Minutes of EMC/Power Working Group Meeting,
Alcatel Space, 05Nov01

Ref: SPIRE-ALC-MOM-
001018

EMC/POWER WORKING GROUP MEETING #12

EMC/Power WG meeting #12

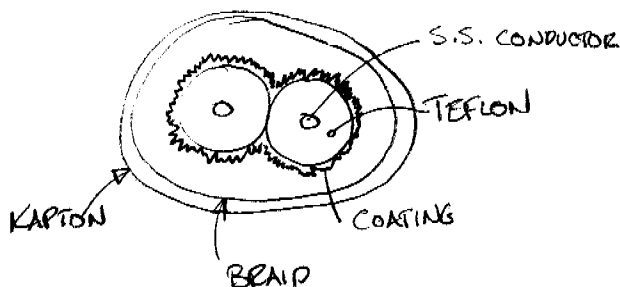
Sensitive to external magnetic field because
no twisting : Gucera is HFI 4K cooler
H field emission.

DY mentions that SST is less fragile for thin
cryo cables.

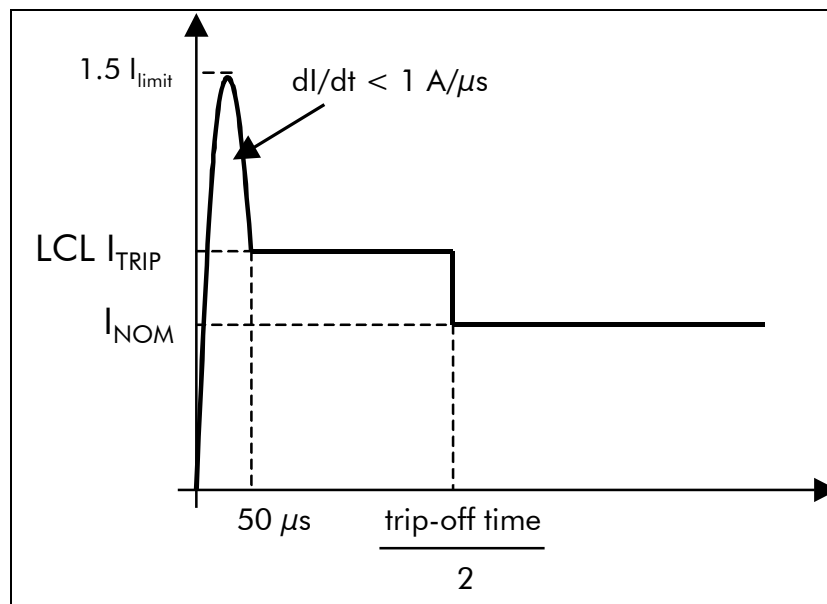
- Comments :

→ Text to be updated :

- limitation of current slope to $1A/\mu s$ ensured by the LCL, not necessarily by the user alone
- $5A \cdot msec = 5 mC$ too high

→ Requirements on user inrush current at switch ON to be introduced in the § 5.14 EMC :

- "plug-in" current specification (switch ON by an external relay)
- inrush current specification (switch ON by an external LCL)

FPU-REU GROUNDING PHILOSOPHY

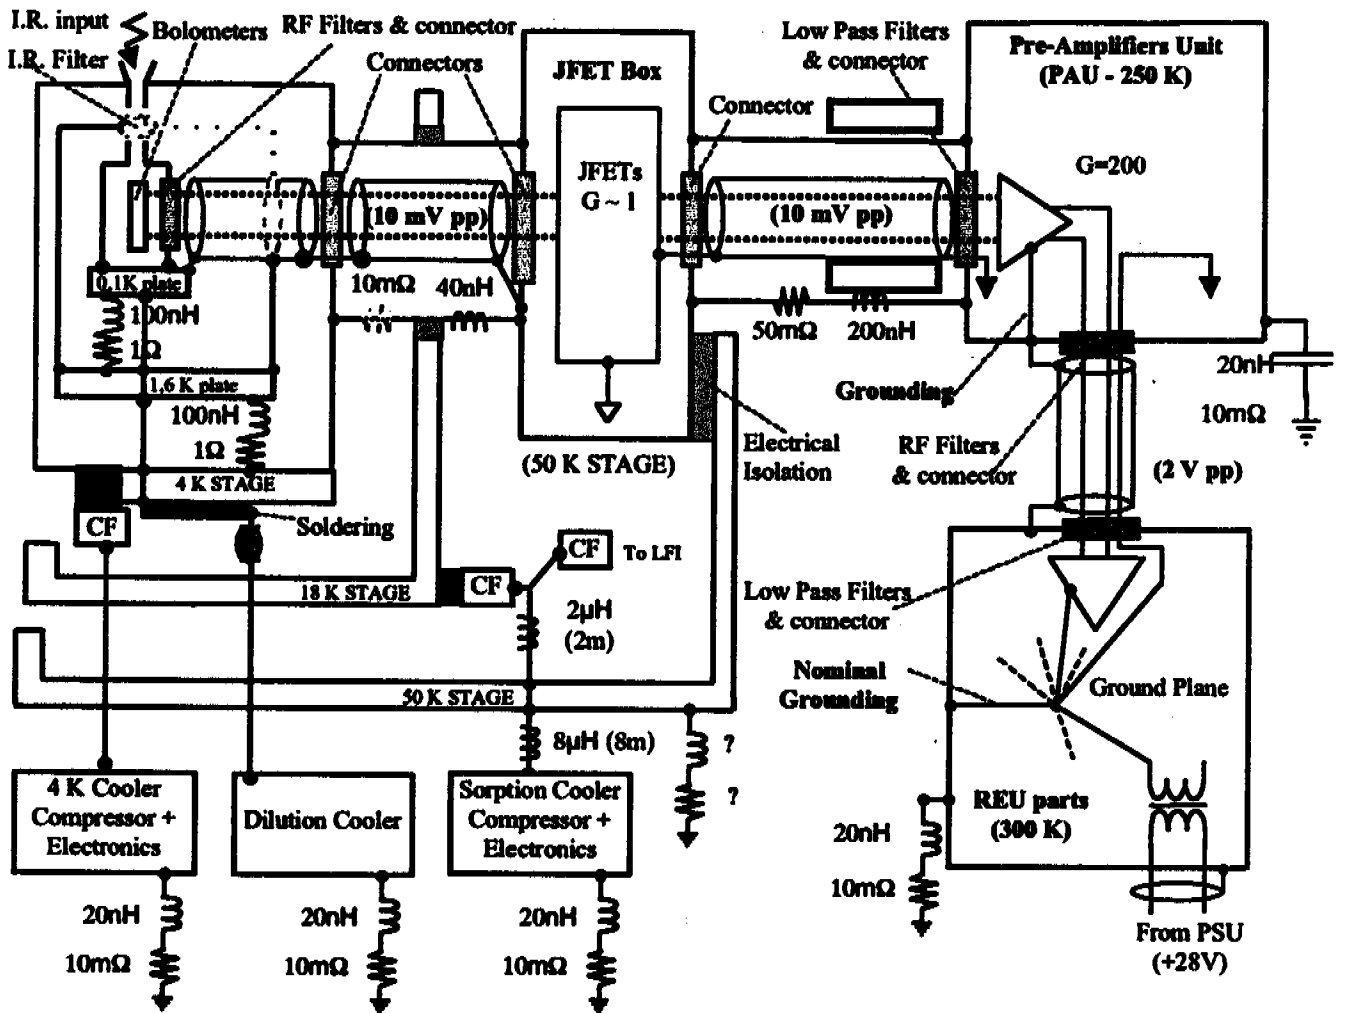
UPDATE REQUIRED

UPDATE REQUIRED

HERSCHEL SPIRE GROUNDING SCHEME

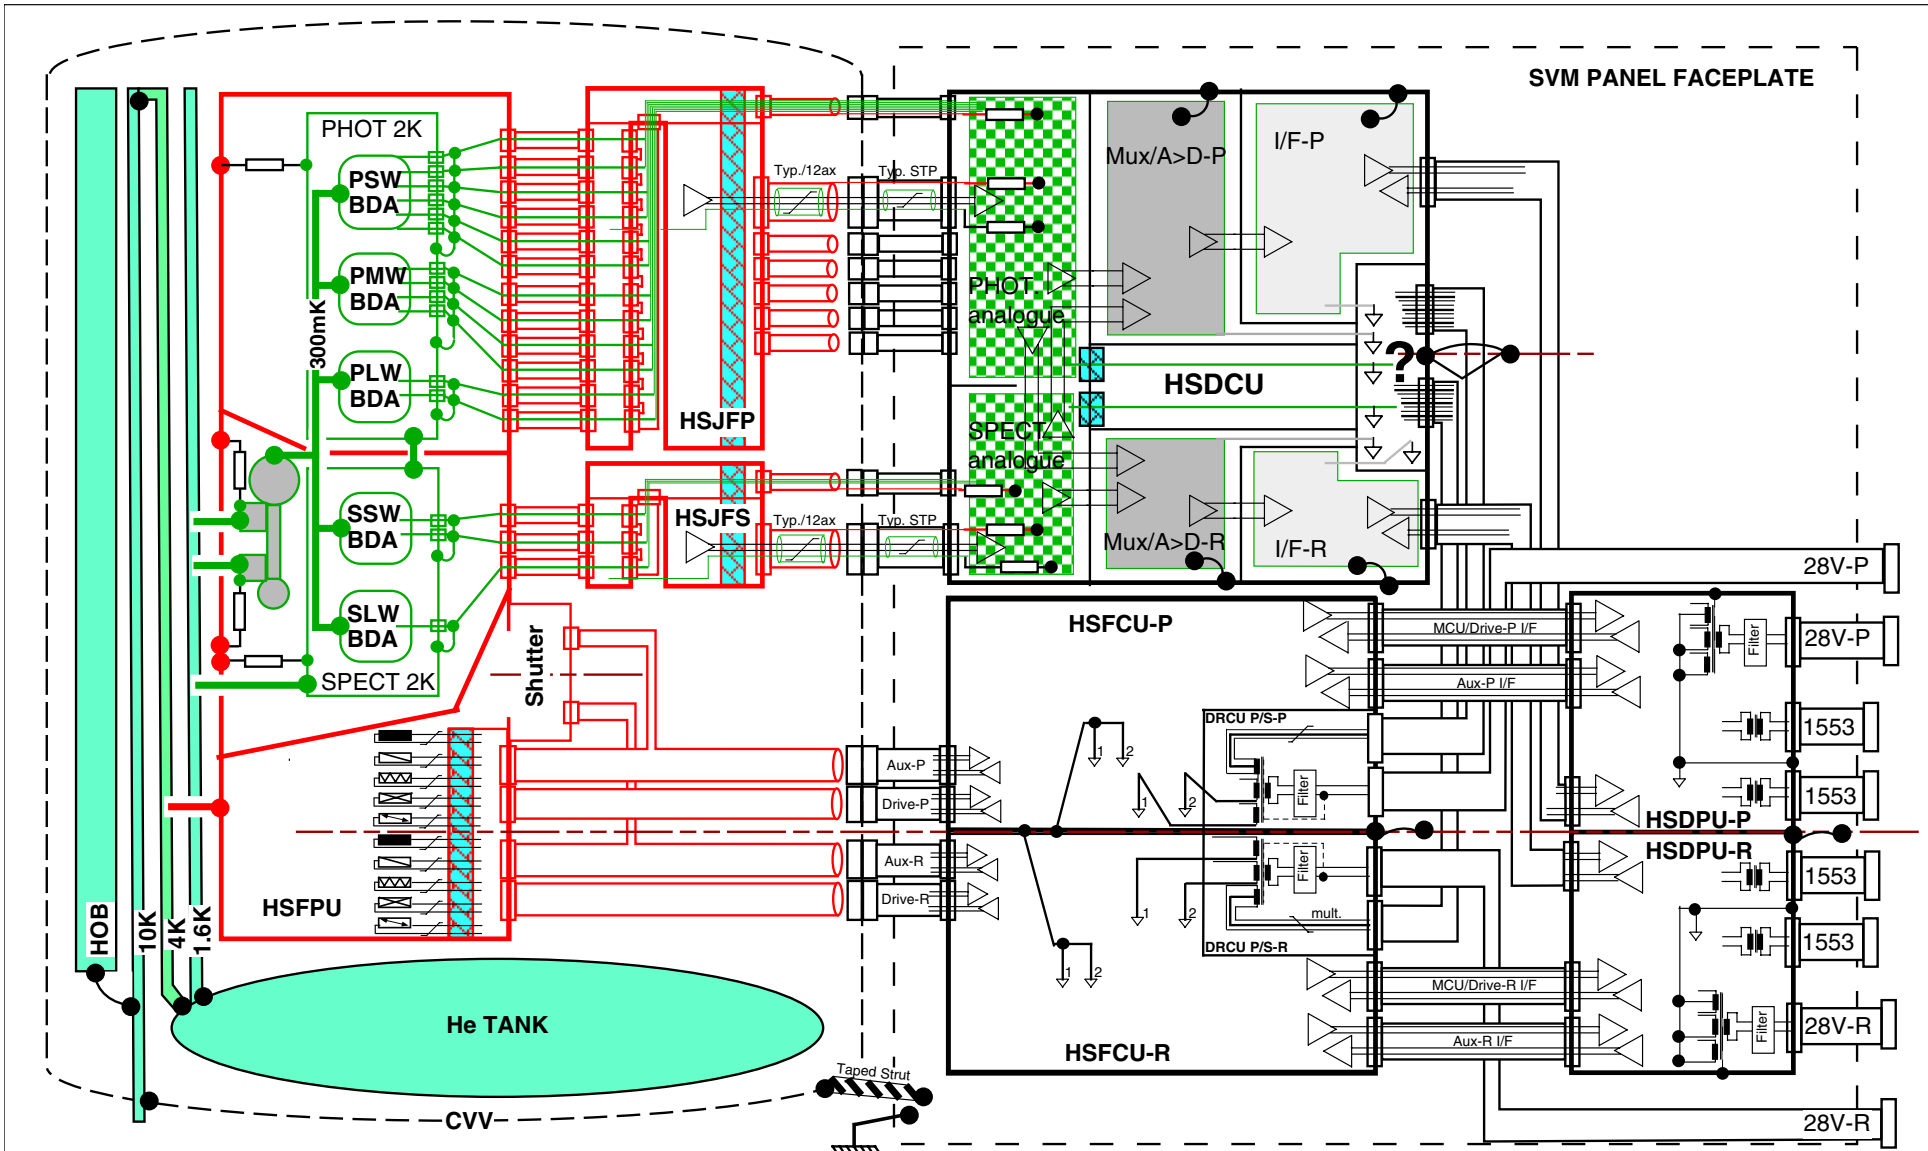
Compromise with ergonomics -
Update design -
